**Victorian Transport Projects Integrated Development
Opportunities Standing Advisory Committee Referral 2**

Rosanna Station

Advisory Committee Report

28 September 2021

Figure 5 South east corner of building - extract of Landscape Plan 01 by Site Image Landscape Architects (VIC)

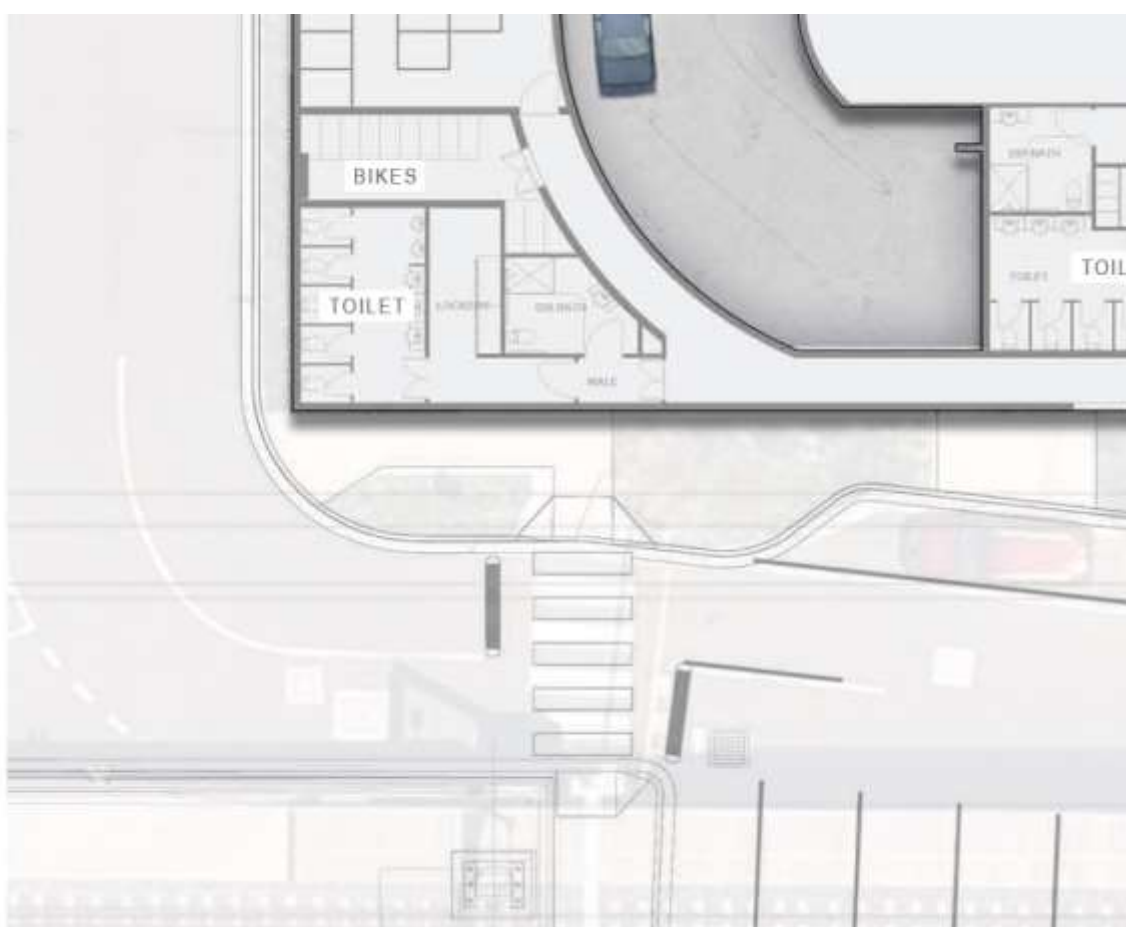
In respect to the rail car park access road, the Committee notes the southeast corner of the building, at ground and basement level, will obstruct sight lines to the pedestrian footpath along the east side of the building that connects the car park to the south with a pedestrian crossing as shown in Figure 5, noting the building is only proposed to be offset one metre from the kerb line. To ensure the safety of pedestrians crossing the road to the south and at the pedestrian crossing to the east, it is important that a sight line splay be provided at this corner of the building at the footpath level.

The Committee is conscious that this was not an issue raised at the Hearing but given the potential safety impact, it is a matter that must be addressed. The dimensions of any setback is a matter that should be determined by Council and the Head, Transport for Victoria as the road authority.

- The location of the car park access is acceptable subject to a sight line splay being provided at the building frontage by splaying the building on the south side of the accessway in accordance with Design Standard 1-Accessways. This is adequately addressed in the proposed condition 1(y).
- A sight line splay is required on the southeast corner of the building to provide adequate sight lines to the public footpath and pedestrian crossing in the rail car park.

Condition 1 be modified by adding two new sub-clauses to read:

“The south east corner of the lot boundary on the subdivision plan be modified to set the property line back to accord with the sight line required for the rail car park access road.”
